INLAND WETLANDS COMMISSION
TUESDAY, January 12, 2021
ZOOM Meeting

Town of Thompson
Inland Wetlands Commission
815 Riverside Drive
North Grosvenordale, CT 06255
860-923-1852 (Office) email: wetlands@thompsonct.org

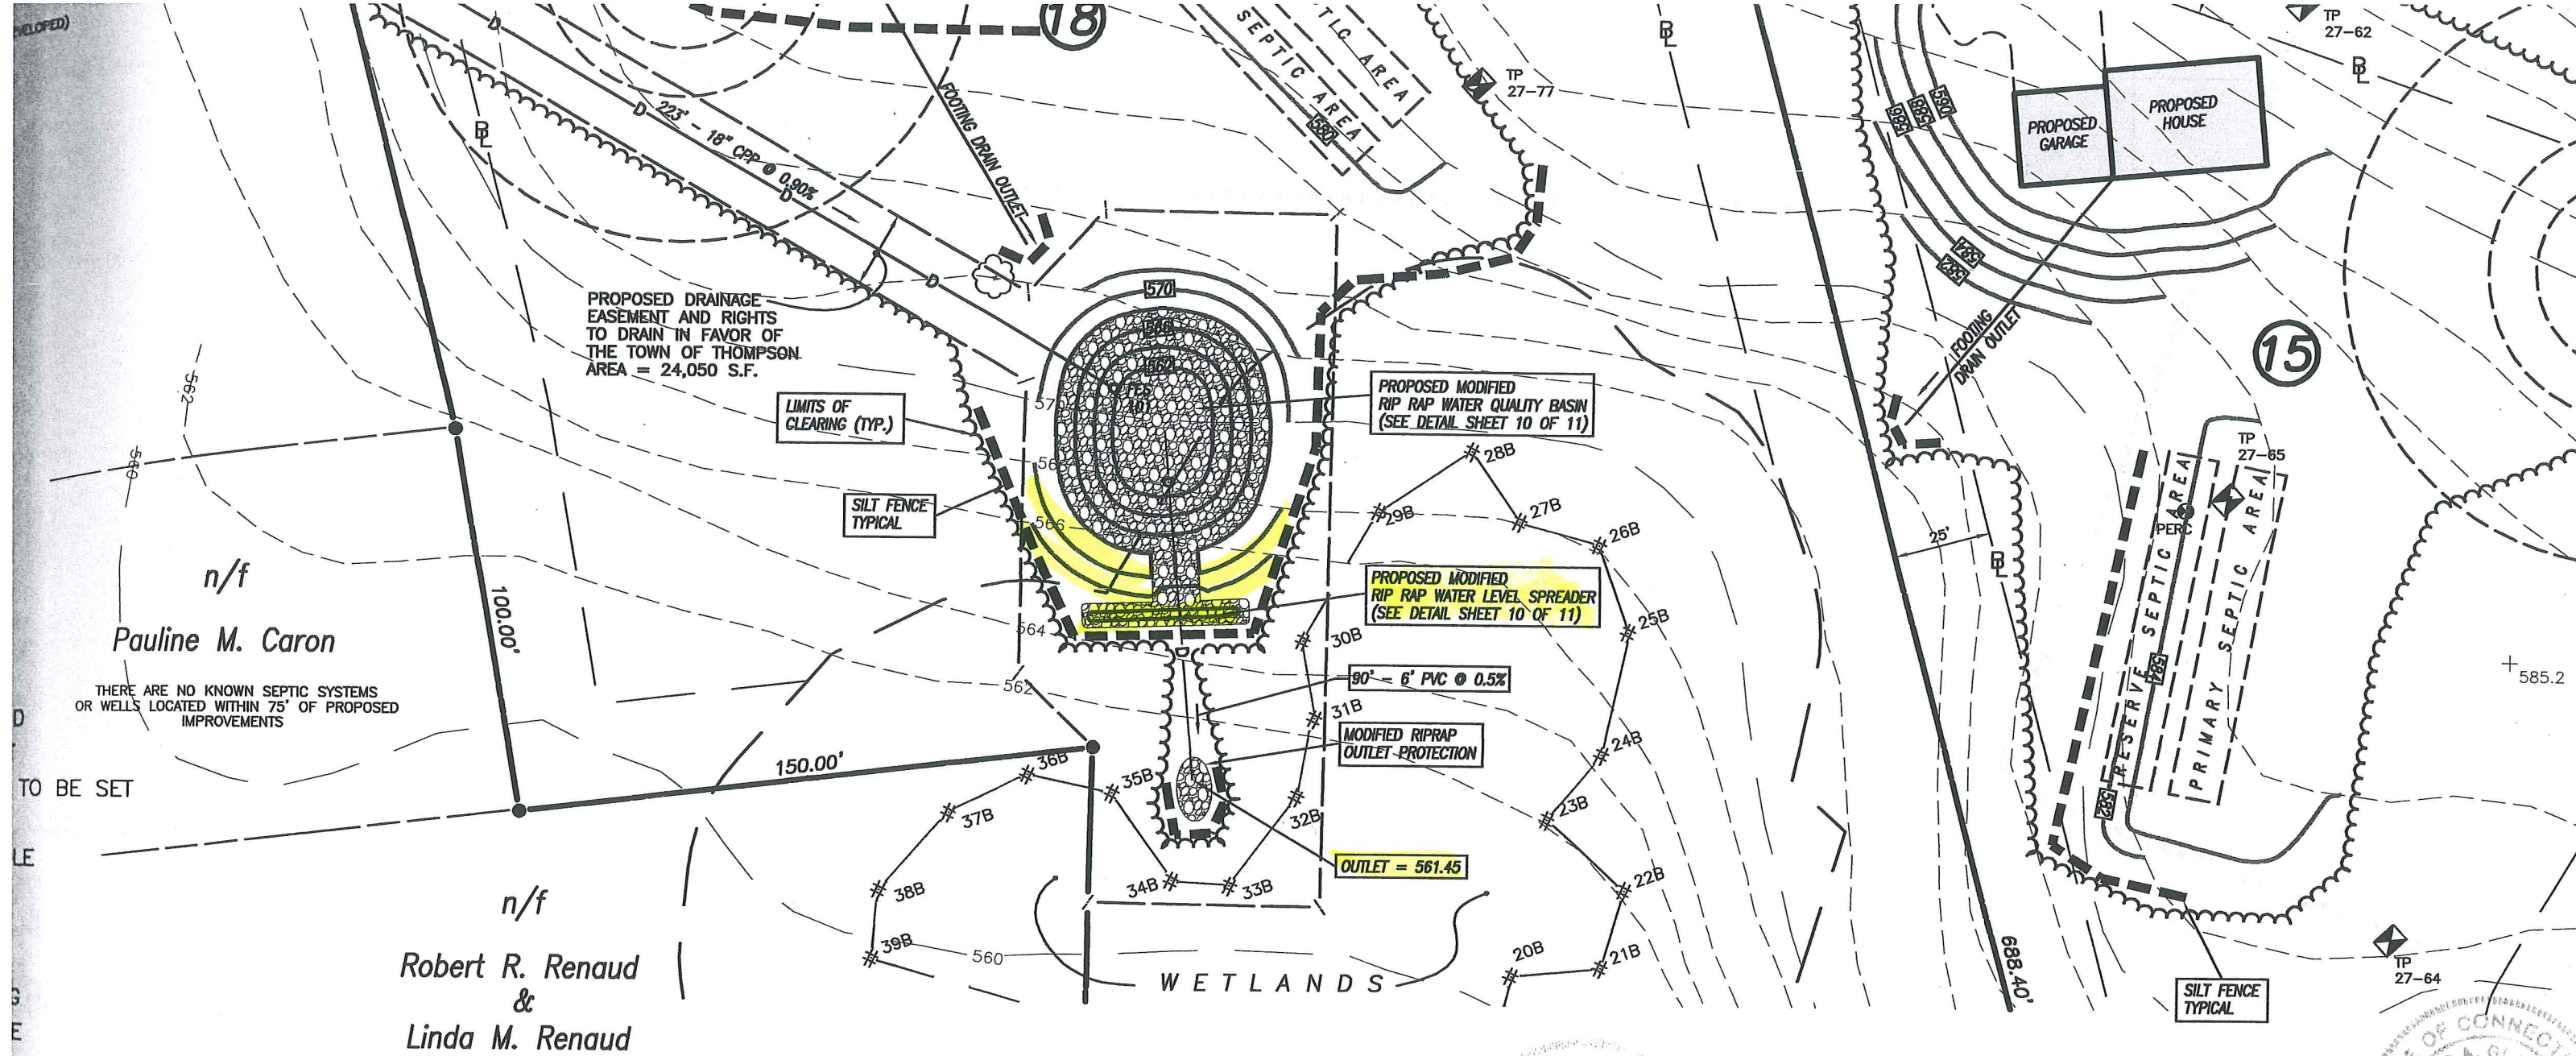
Attached you will find my notes regarding the discrepancies between the approved drawings and the as-built drawing for the stormwater management basin located on lot 18, which lot is the subject of Wetlands Agent Approval Application WAA20034. Because the dimensions of the basin are altered as well as the outlet elevations please provide an engineering analysis of the function of the built basin in comparison to that of the approved design (per Permit IWA17001 as modified) and provide a statement by a professional engineer licensed to practice in Connecticut as to the conclusion of that analysis. Please provide a response within 2 weeks so that I can complete the processing of application WAA20034. Thank you. - Marla

DATE: 10/29/2020	DRAWN: AMR
SCALE: 1" = 40'	DESIGN: --
SHEET: 1 OF 1	CHK BY: GG
DWG. No: CLIENT FILE	JOB No: 15048

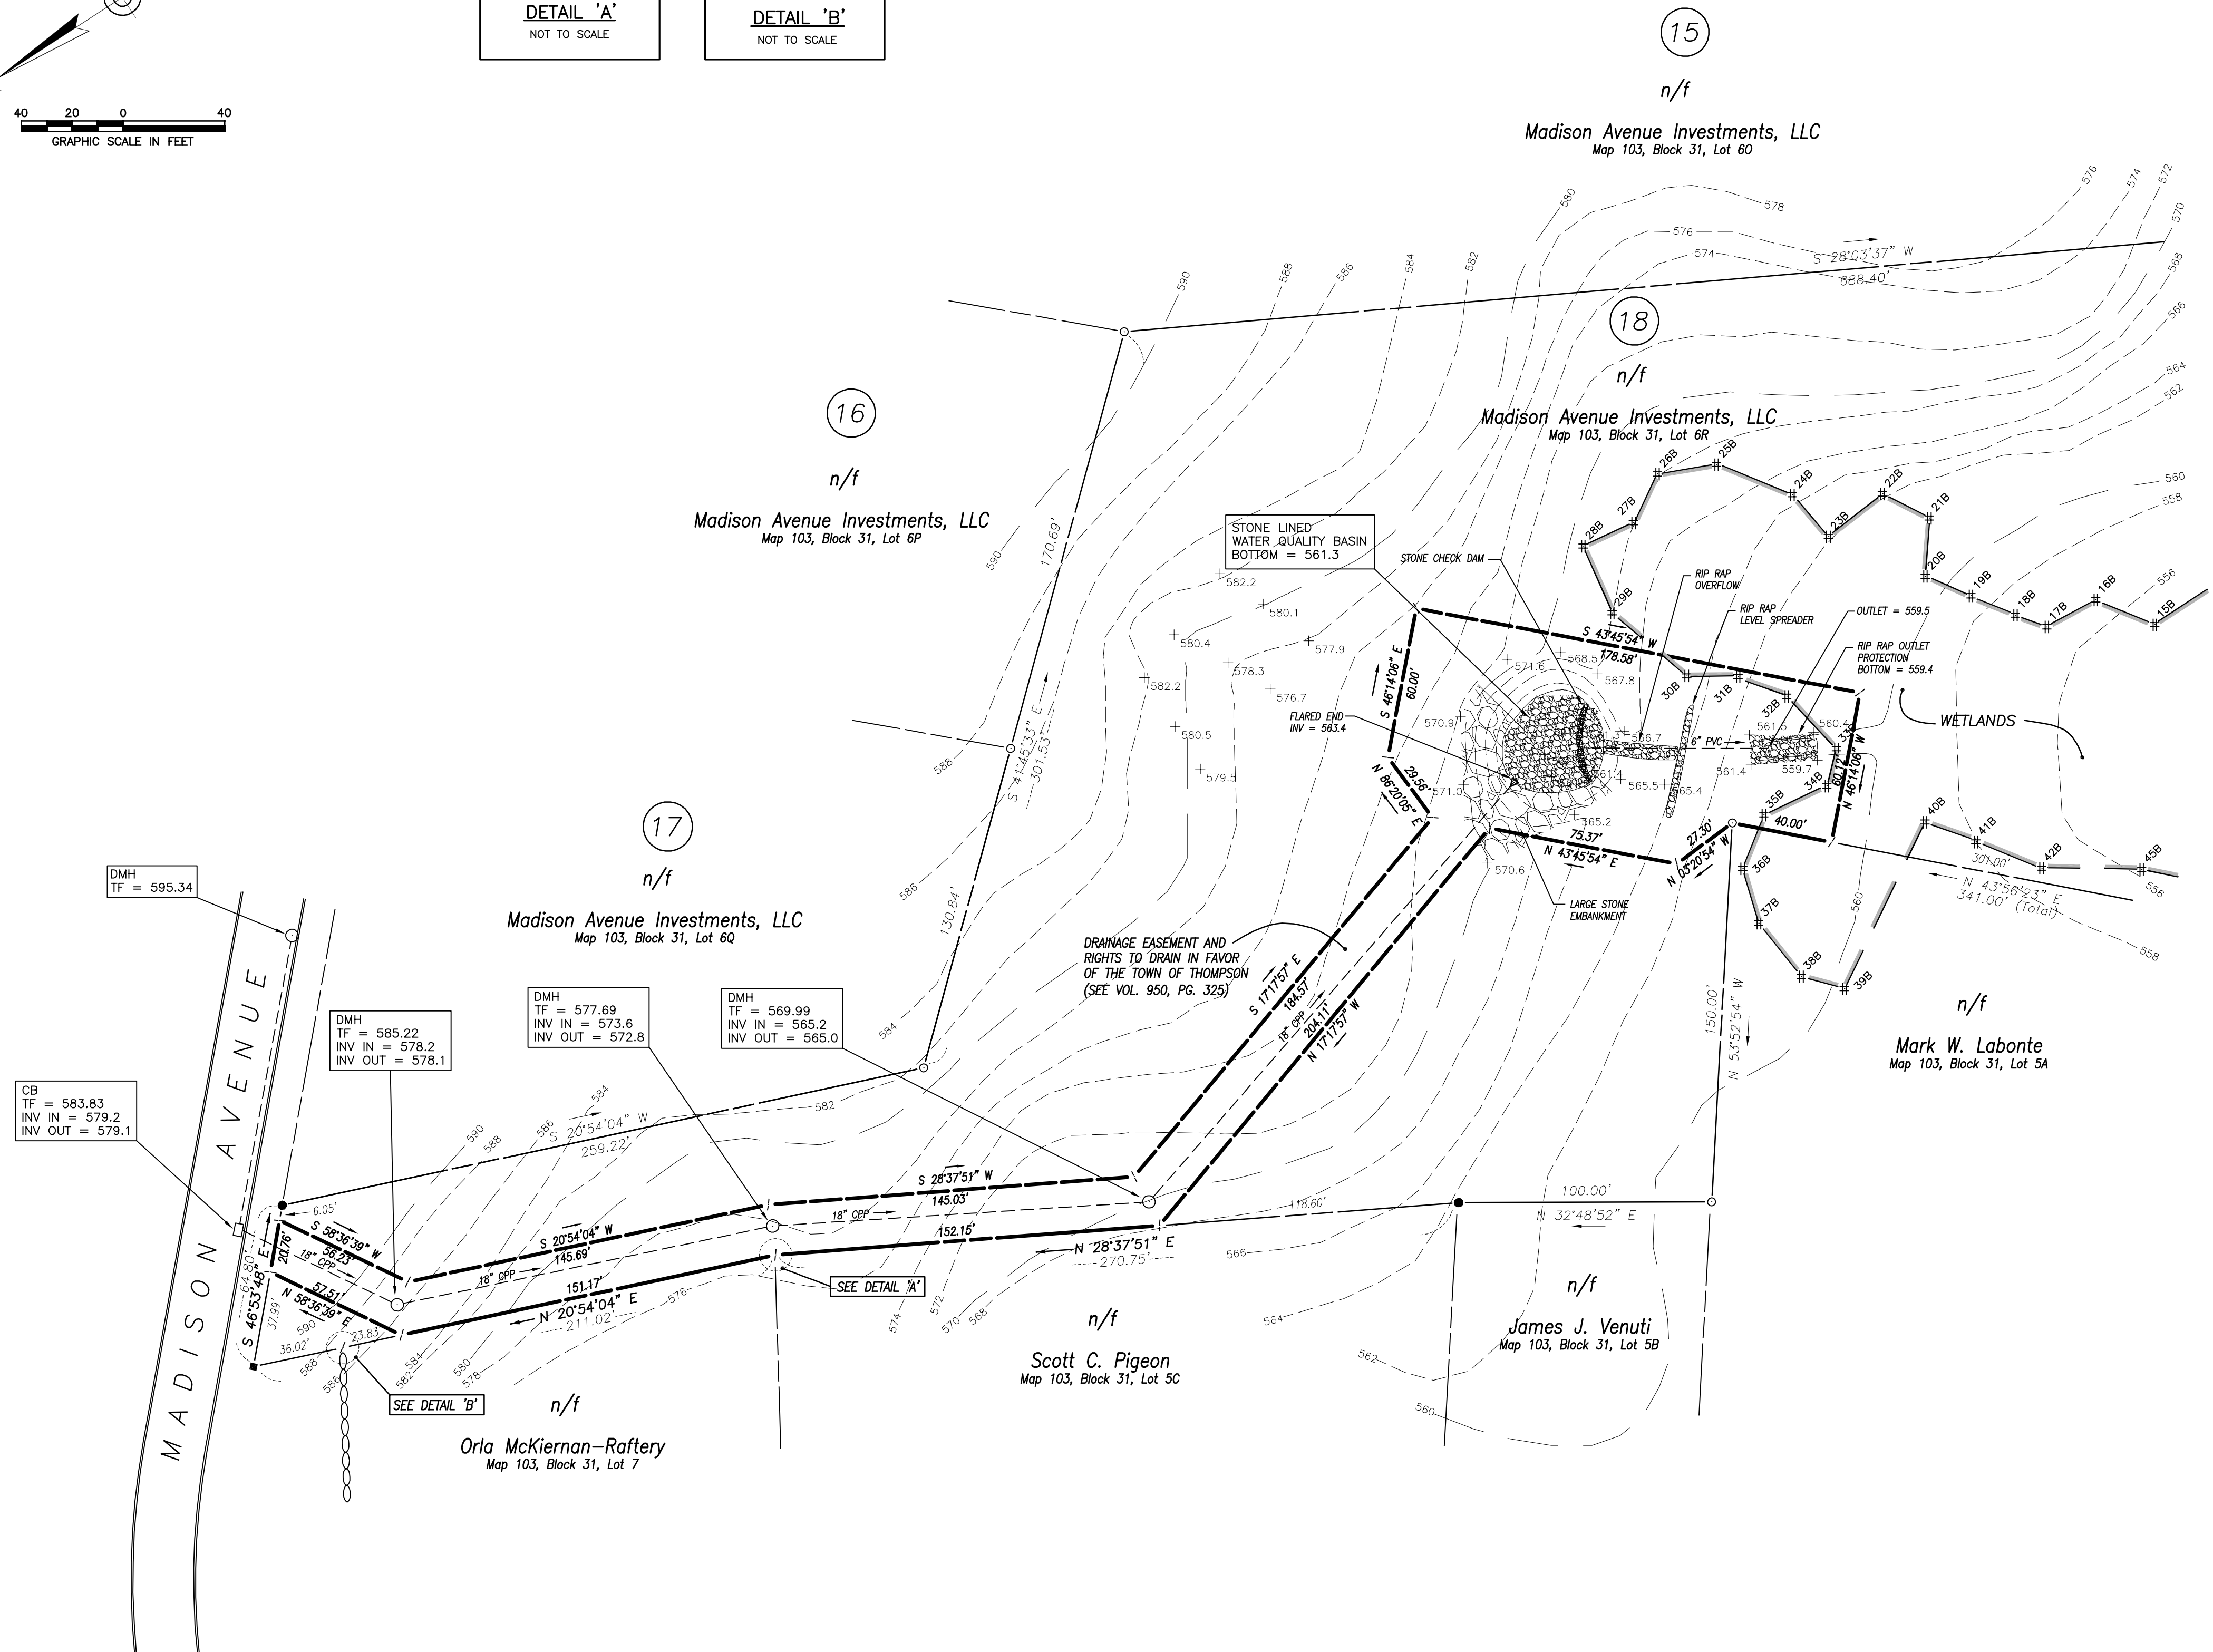
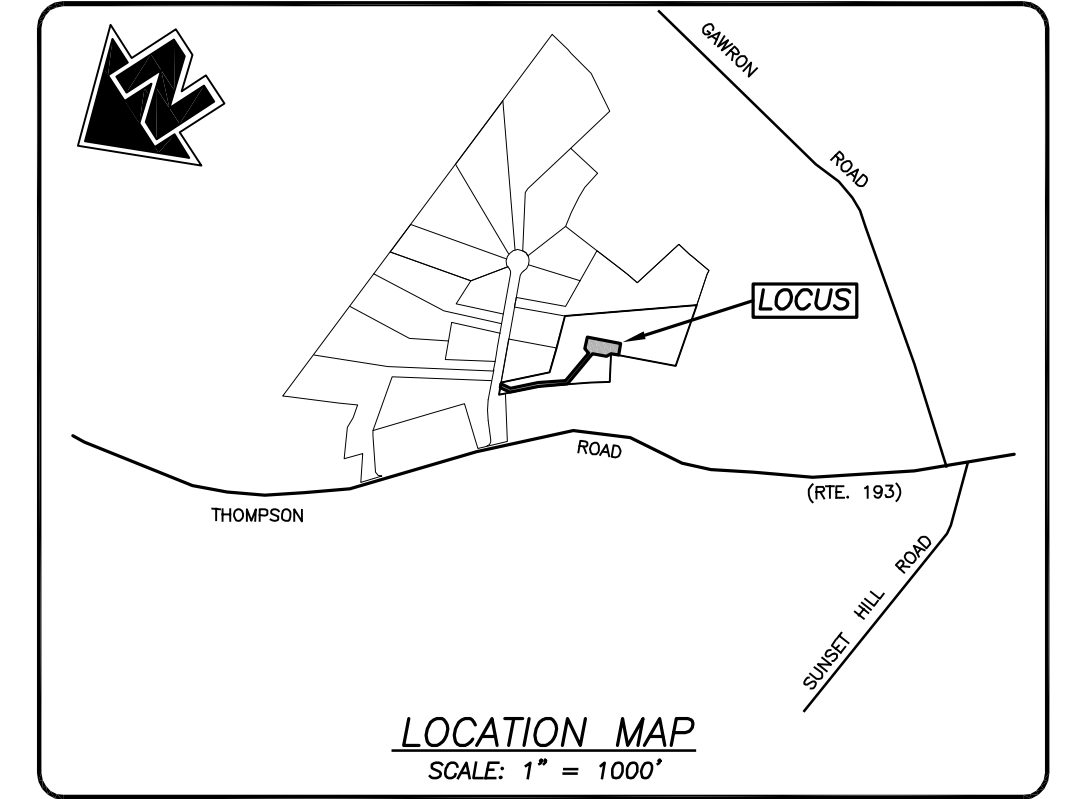
Also attached is an as-built drawing of the drainage system and stormwater drainage system that I requested and received from Killingly Engineering. There are some discrepancies between what was authorized and what was built that I need to determine if that is a problem. However, the layout of the easement lines are the same as that which was approved in the recorded subdivision plans.

Please advise me if the language of the easement language is acceptable to the Town or if it needs to be modified. Thank you.-Marla
